Re: Biogen Tank & Enclosure

Planning Board Approval

SMMA No. 21070

BIOGEN BUILDING 8 - TANKS & ENCLOSURE
 FIGURE 3: PROPOSED SITE PLAN & SECTION

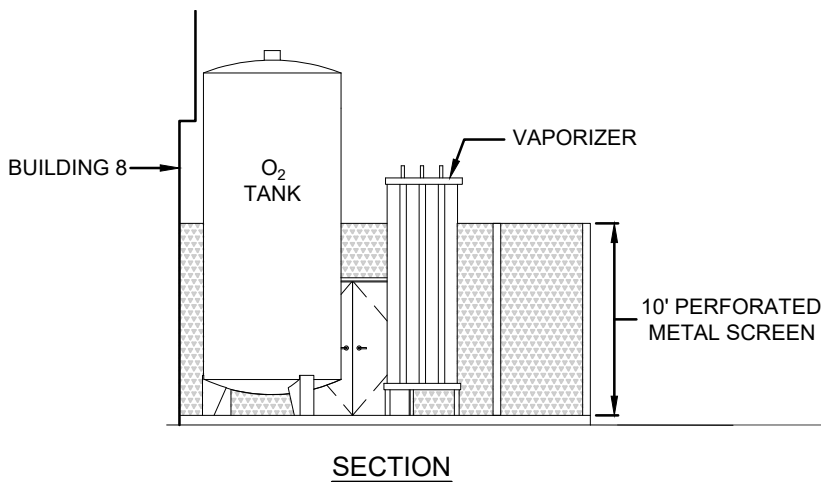
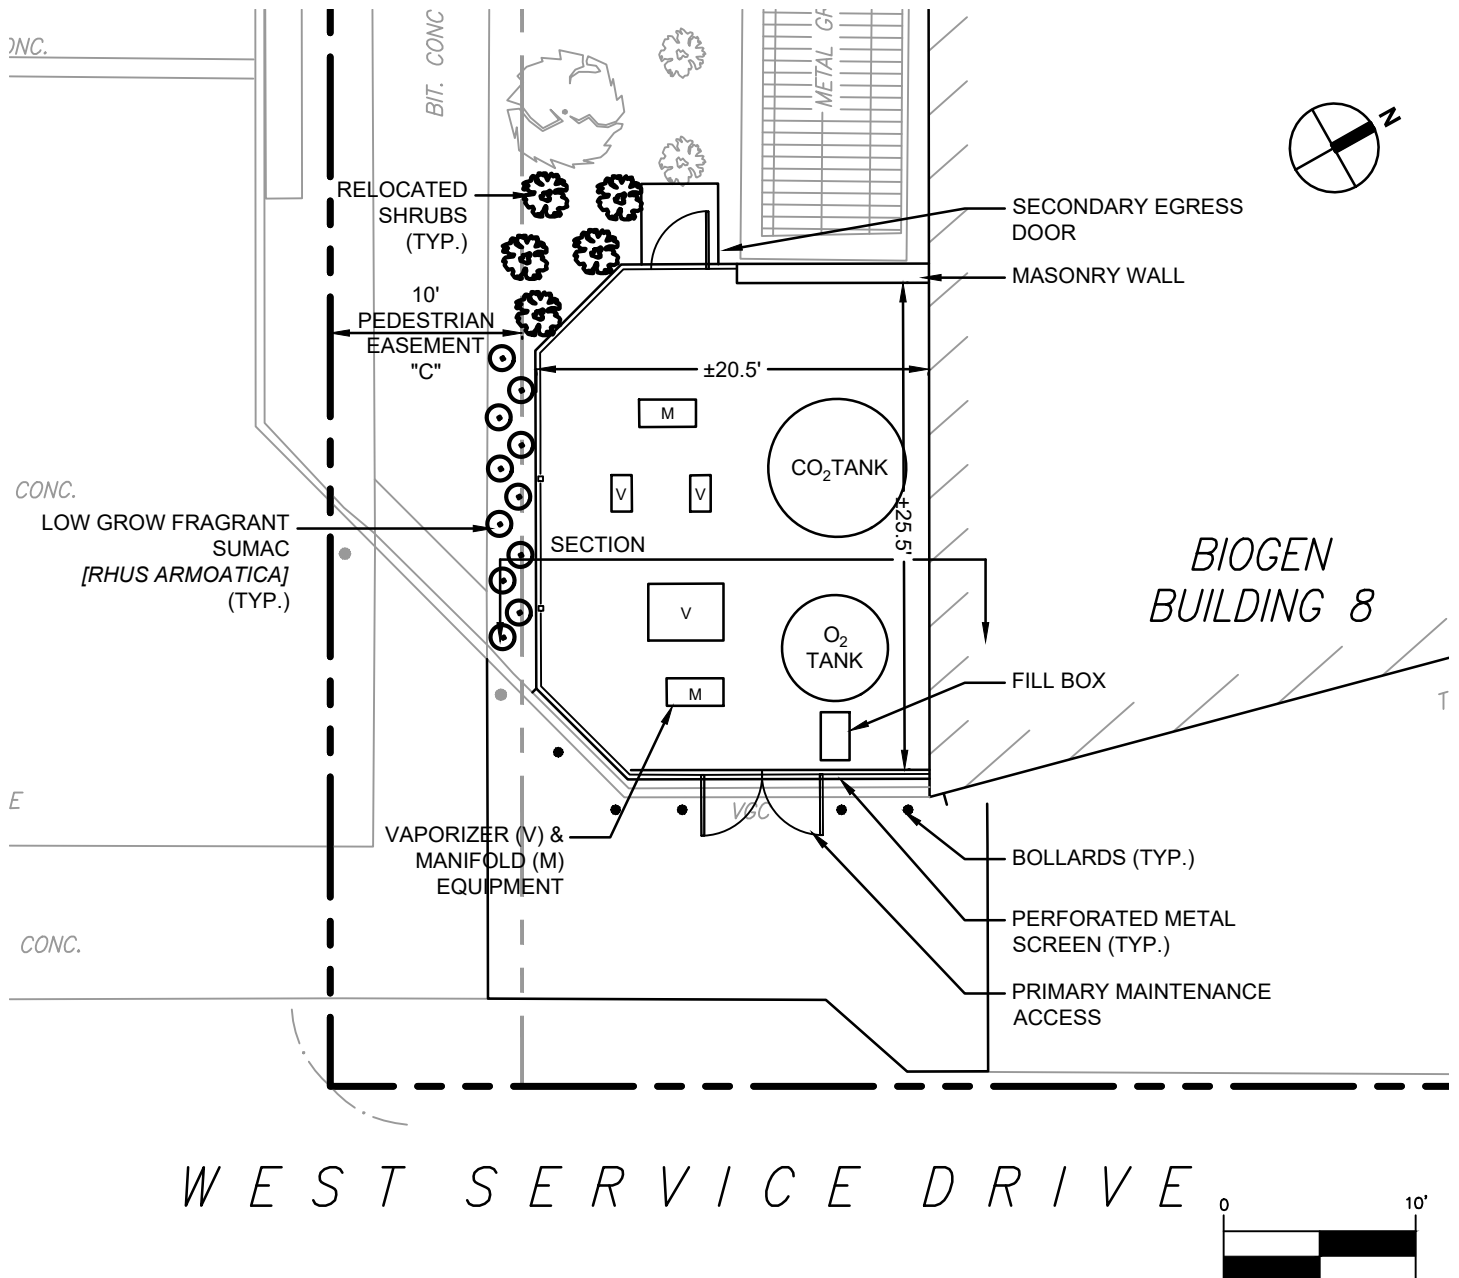
An initial comment from the Cambridge Redevelopment Authority (CRA) raised the question of whether this pad and its enclosure could be moved further into the site and off of the roadway edge. It was originally thought that this might be possible as there is a small (2'-6" wide) stone strip between the pad and an existing underground areaway. Upon further evaluation, SMMA has determined that the pad/enclosure cannot be moved from where it currently is proposed as doing so would cause the fire rated wall portion of the west enclosure to intrude upon the exhaust fan/louver opening and nullify the protection provided by the wall.

SMMA and CRA reviewed the project at a design review meeting on September 7th, 2022 where we received feedback on the proposed tank orientation (revise to be east-west along building face), relocation of the egress (personnel) door from the south side to the west side, a request for further review of potential increase in setbacks, screen vs. tank height – ongoing review by CRA, and a question on the time duration for filling tanks. The design and supplemental information was subsequently updated and resubmitted to CRA on September 14th, 2022.

Additional Design Review Committee comments included 1.) Not opposed to open fence design, just ask that fence geometry (horizontal rails) try to align w/ building lines, if possible, 2.) could pad color match bldg. base color (darker than concrete), 3.) could tank colors match adjacent bldg. louver colors? 4.) could tanks be painted ala like an art canvas? 5.) if open fence could another layer of applied ornamentation be added to fence? (A/E/owner felt #5 is subjective and has too many varying solutions) 6.) would a vegetative green wall be considered (team reviewed and determined it would be a security and ongoing maintenance issue).

For these reasons, SMMA proposes that the enclosure remain partially of masonry block (where required due to code) but mostly of a transparent design. Following up on comments made at the November 1, 2022 Design Review Committee (DRC) meeting, the design team has reviewed and proposes a revised option for providing an enclosure with a similar look and feel as other fencing already in use on this site, located along the property line to the west. The revised tank enclosure, shown in Figure 4, consists of the masonry portion as previously indicated coupled with a transparent steel security fence with a revised detail at the top of the fencing portion. The security fence is envisioned to be 8'-0" high above the concrete slab with 1-inch square vertical steel balusters at approximately 5-inches on center. The arrowhead design, previously submitted at the top of the balusters, has been removed in favor of a simpler beveled edge treatment. The current design also features two horizontal baluster supports, placed at approximately 6'-10" and 7'-4" respectively above the slab. Additional details such as circular accents may be placed within the zones bound by the balusters and the horizontal supports or left blank (open) as is currently shown, at the Design Review Committee's preference. An additional horizontal support will be placed near the bottom of the screen element, at approximately 5-inches above the slab. SMMA's opinion is that this scenario offers the best of all concerns while blending in harmony with the fencing already onsite as well as at similar tank-type facilities located throughout the neighborhood.
